U.S. NUCLEAR REGULATORY COMMISSION
REGION I

Report No. 93-02

Facility: Vermont Yankee Nuclear Power Station
Vernon, Vermont

Inspection Period: January 3 - February 5, 1993

PENETRATION TG-0329 SF

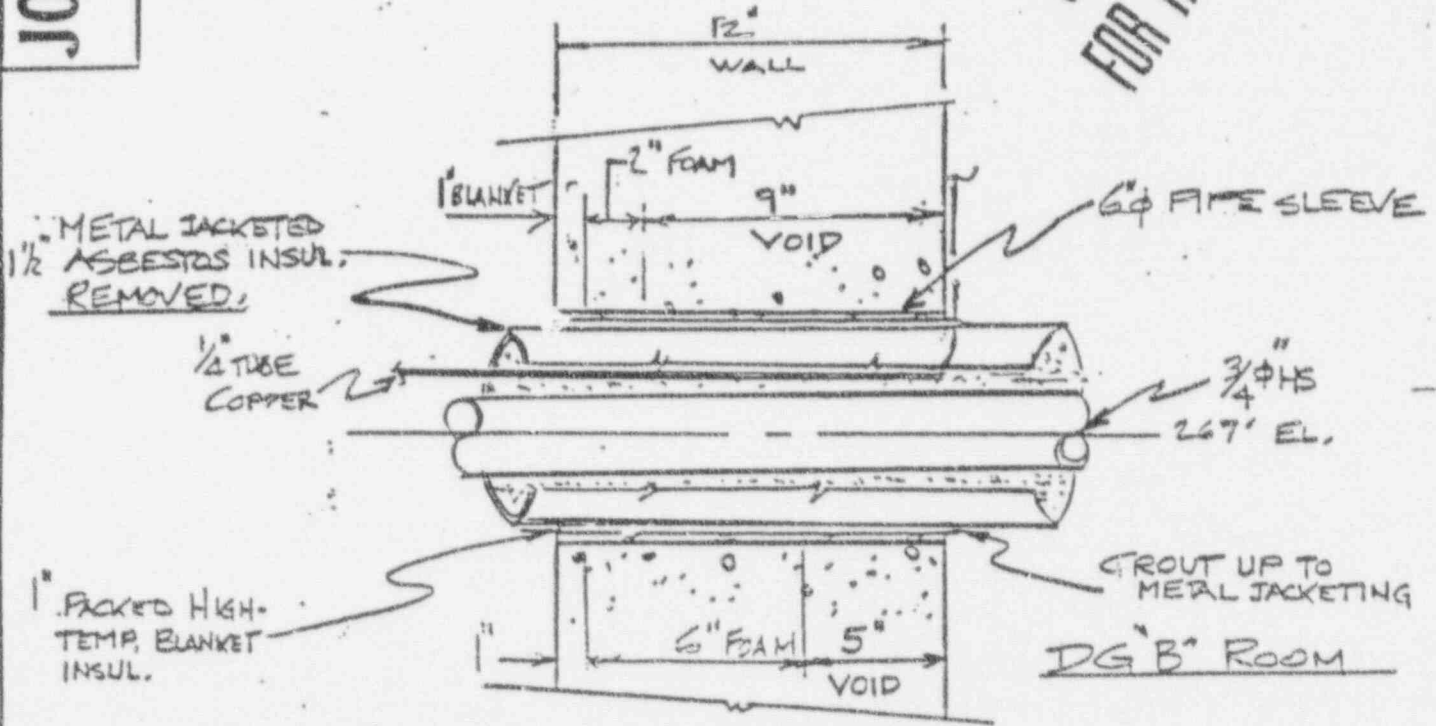
12 NOT ACCEPTABLE TO '79 STANDARDS

- **MECHANICAL PENETRATION/NO COMBUSTIBLES OR SOURCES OF IGNITION**
- **MAJORITY WOULD HAVE MET 1979 DESIGN CRITERIA**
- **PENETRATIONS WERE FILLED WITH INSULATION**
- **LARGE GAPS WERE FOAMED OR GROUTED**
- **SMALL GAPS WERE CAULKED OR GROUTED**
- **NO SAFETY SIGNIFICANT DISCREPANCIES**

- **INSPECT ALL PENETRATIONS AND REPAIR, IF APPROPRIATE**
- **SOME PENETRATIONS ACCEPTABLE AS-IS**
- **REPAIR OPTIONS:**
 - o **FOAM PER ORIGINAL DESIGN**
 - o **ENHANCED BISCO FOAM DESIGN**
 - o **ENGINEERED 'BOOT' FOR LINES WITH THERMAL GROWTH**
 - o **GROUT PENETRATION**

PENETRATION TG-0305-SF

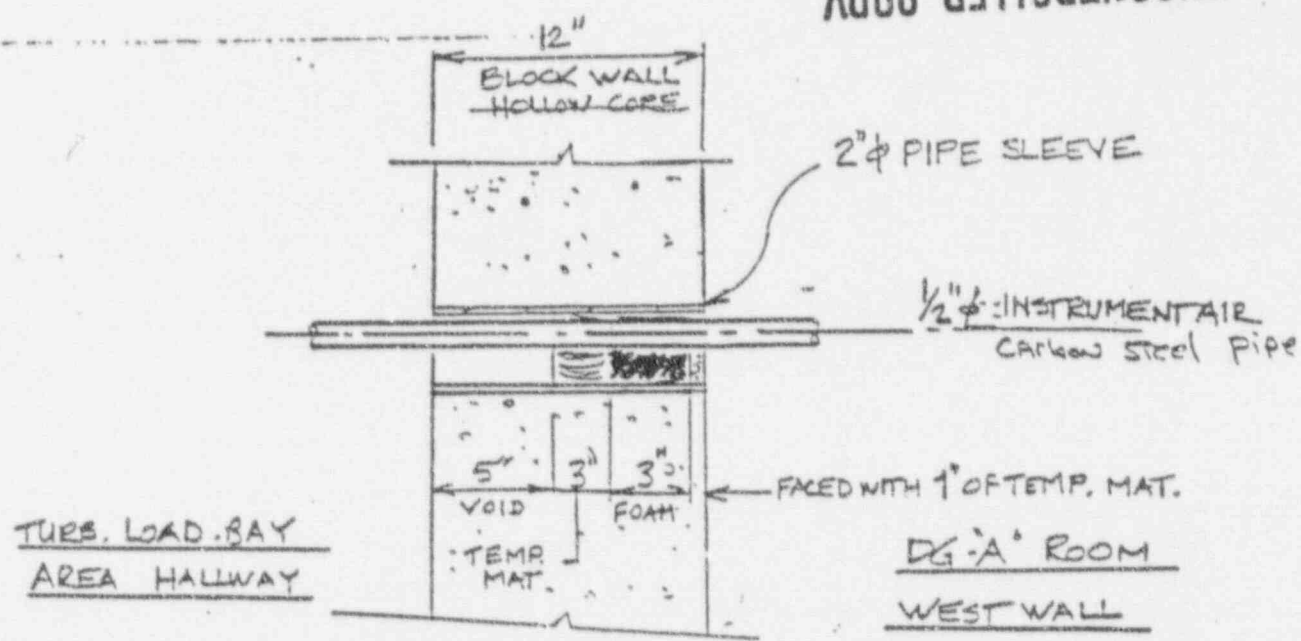
2 NOT ACCEPTABLE TO '79 STANDARDS

- **MECHANICAL PENETRATIONS/NO COMBUSTIBLES OR SOURCES OF IGNITION**
- **MAJORITY WOULD HAVE MET 1979 DESIGN CRITERIA**
- **PENETRATIONS GROUTED OR FILLED WITH FOAM**
- **NO SAFETY SIGNIFICANT DISCREPANCIES IDENTIFIED**

- **PERFORM ENHANCED REFUEL CYCLE SURVEILLANCE ON AN EXPEDITED SCHEDULE**
- **WILL IMPROVE SEALS IF PROBLEMS IDENTIFIED**
